ENGINE - LP COMPRESSOR - PROVIDE MARKING INSTRUCTION FOR VARIOUS MAJOR ASSEMBLIES -
CATEGORY CODE 6 - MOD.ENG-72-0066

V2500-ENG-72-0066

Fig.1

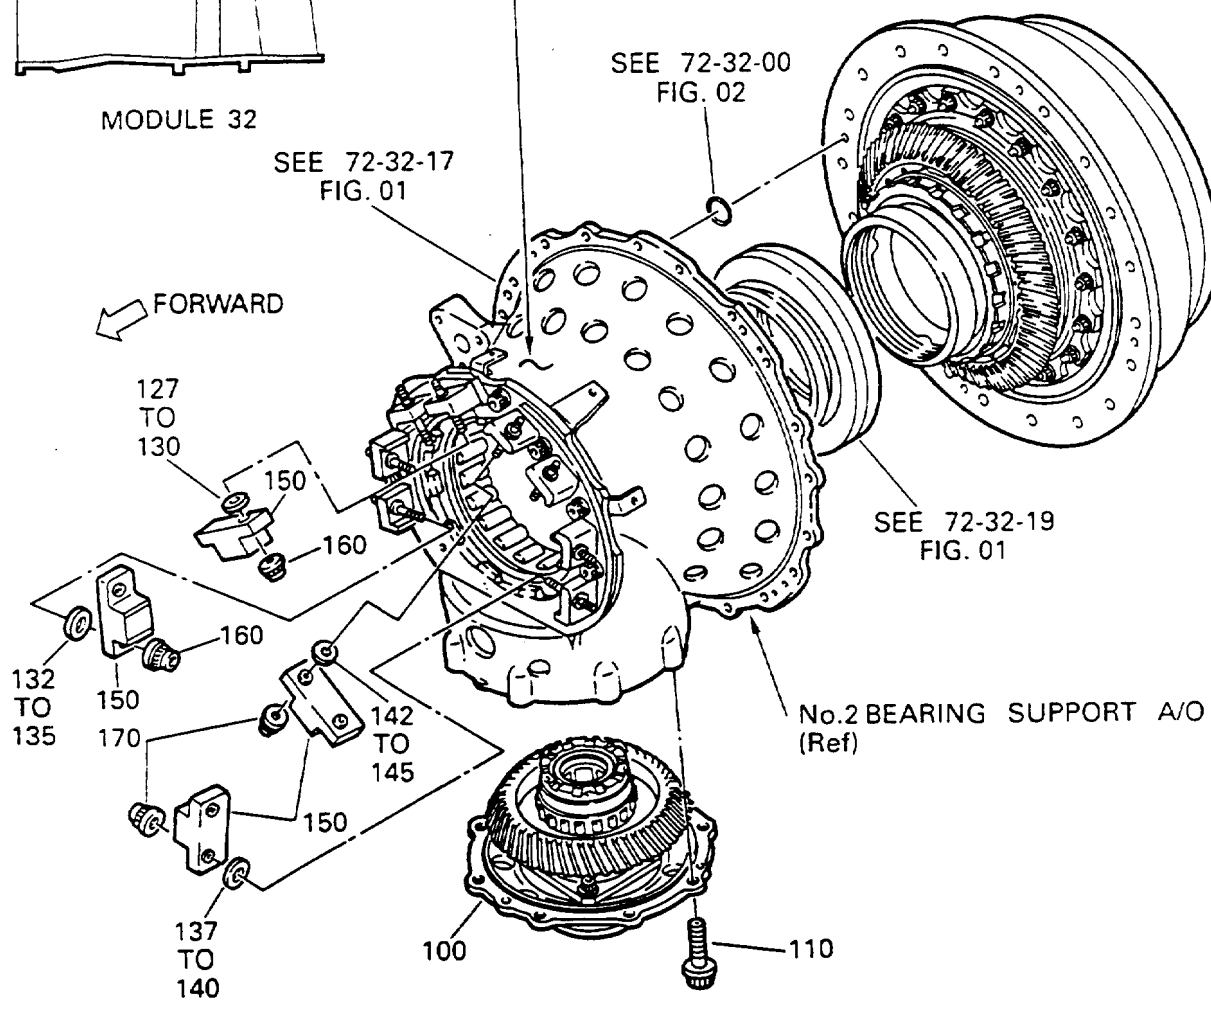
MARK NEW PN 5W0099 WHICH IS FOLLOWED BY LETTERS "SUB-MODULE" WITH VIBRO-PEEN NEAR THE EXISTING PN OF No.2 BEARING SUPPORT A/O IDENTIFIED HERE.

MARK THE SERIAL NUMBER SPECIFIED IN SECTION 2.A.NOTE, WITH VIBRO-PEEN ADJACENT TO NEW PN 5W0099.

- (a) Mark a new Part Number 5W0099 which is followed by the letters "SUB-MODULE" (i.e. SUB-MODULE 5W0099) with Vibro-peen near the existing Part Number of No.2 Bearing support A/0. (Refer to Figure 1, and 1.K.(3)).
- (b) Mark the Serial Number with Vibro-peen adjacent to the new Part Number 5W0099 marked on the No.2 Bearing support A/0. (Refer to Figure 1, 1.K. (3), and 2.A. Note).

Marking of the Part Number and the Serial Number on LP Shaft, No.1 and No.2 Bearing
Assembly
Fig.2

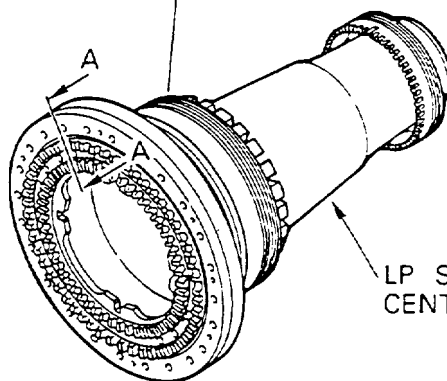
MARK NEW PN 5W0098 WHICH IS FOLLOWED
BY LETTERS "SUB-MODULE" WITH VIBRO-
PEEN NEAR THE EXISTING PN OF LP STUB
SHAFT ROTOR CENTER A/O IDENTIFIED
HERE. (See 2.A. (2). (a).)
MARK THE SERIAL NUMBER SPECIFIED IN
SECTION 2.A. NOTE, WITH VIBRO-PEEN
ADJACENT TO NEW PN 5W0098.
(See 2.A. (2). (b).)

MARKING IS NOT PERMITTED
ON THIS AREA.

- (a) Mark a new Part Number 5W0098 which is followed by the letters "SUB-MODULE" (i.e. SUB-MODULE 5W0098) with Vibro-peen near the existing Part Number of LPc Stub Shaft Rotor Center A/0 marked on its front surface. (Refer to Figure 2, and 1.K.(3)).
- (b) Mark the Serial Number with Vibro-peen adjacent to the new Part Number 5W0098 marked on the front surface of LP Stub Shaft Rotor Center A/0. (Refer to Figure 2, 1.K.(3), and 2.A. Note).

Marking of the Part Number and the Serial Number on LP Compressor Stage 1.5, 2 and 2.5 Assembly
Fig.3

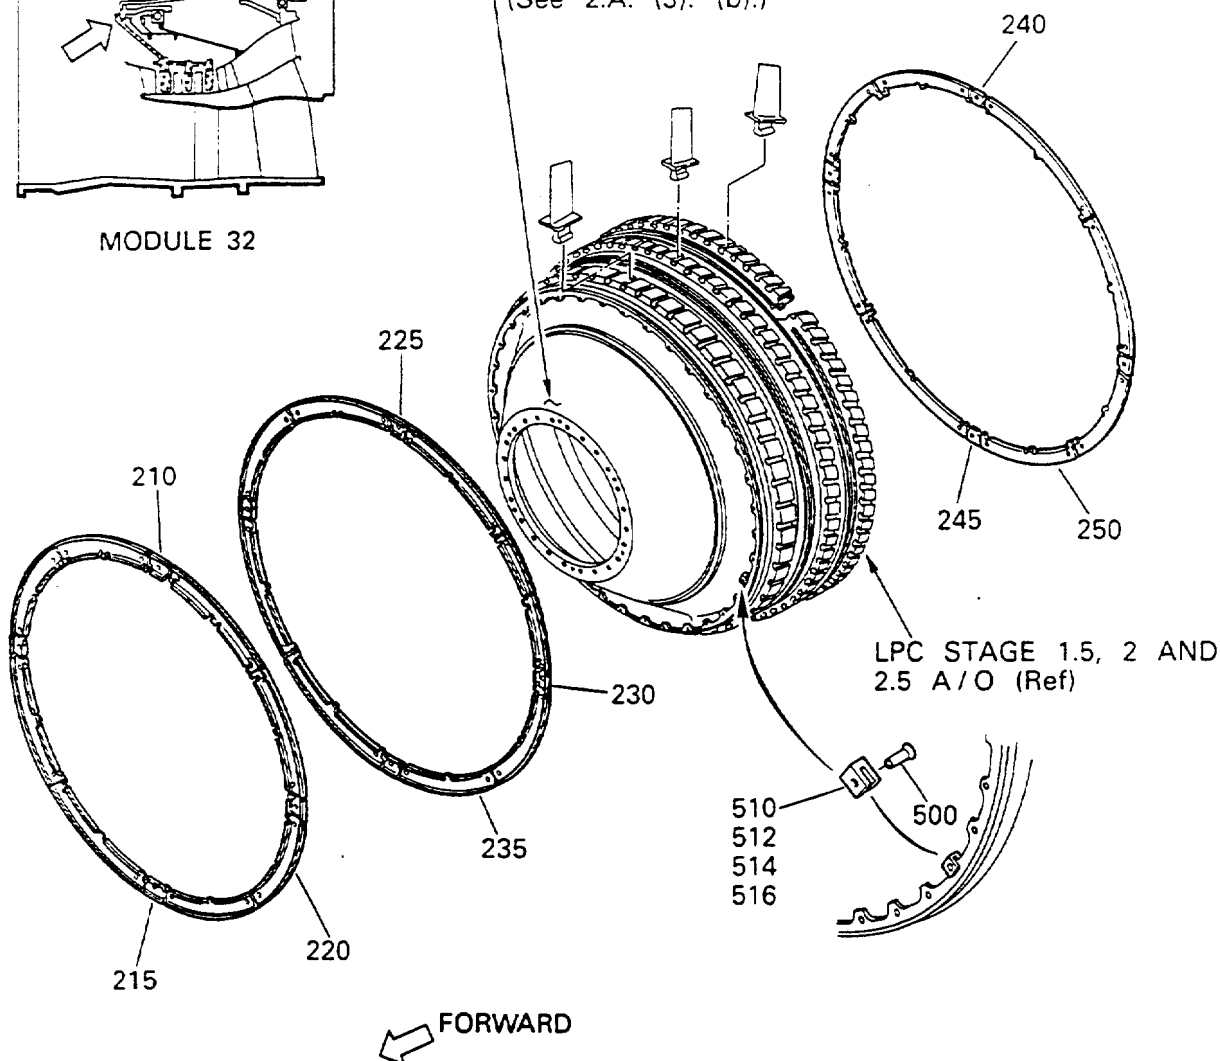
MARK NEW PN 5W0097 WHICH IS FOLLOWED BY LETTERS "SUB-MODULE" WITH ELECTRO-CHEMICAL ETCHING NEAR THE EXISTING PN OF LPC STAGE 1.5, 2 AND 2.5 DISC A/O IDENTIFIED HERE. (See 2.A. (3). (a).)
MARK THE SERIAL NUMBER SPECIFIED IN SECTION 2.A. NOTE, WITH ELECTROCHEMICAL ETCHING ADJACENT TO NEW PN 5W0097. (See 2.A. (3). (b).)

- (a) Mark a new Part Number 5W0097 which is followed by the letters "SUB-MODULE" (i.e. "SUB-MODULE 5W0097) with Electrochemical Etching near the existing Part Number of LPC Stage 1.5, 2 and 2.5 Disc A/0. (Refer to Figure 3, and 1.K.(3)).

- (b) Mark the Serial Number with Electrochemical Etching adjacent to the new Part Number 5W0097 marked on the LPC Stage 1.5, 2 and 2.5 Disc A/O. (Refer to Figure 3, 1.K.(3), and 2.A. Note).
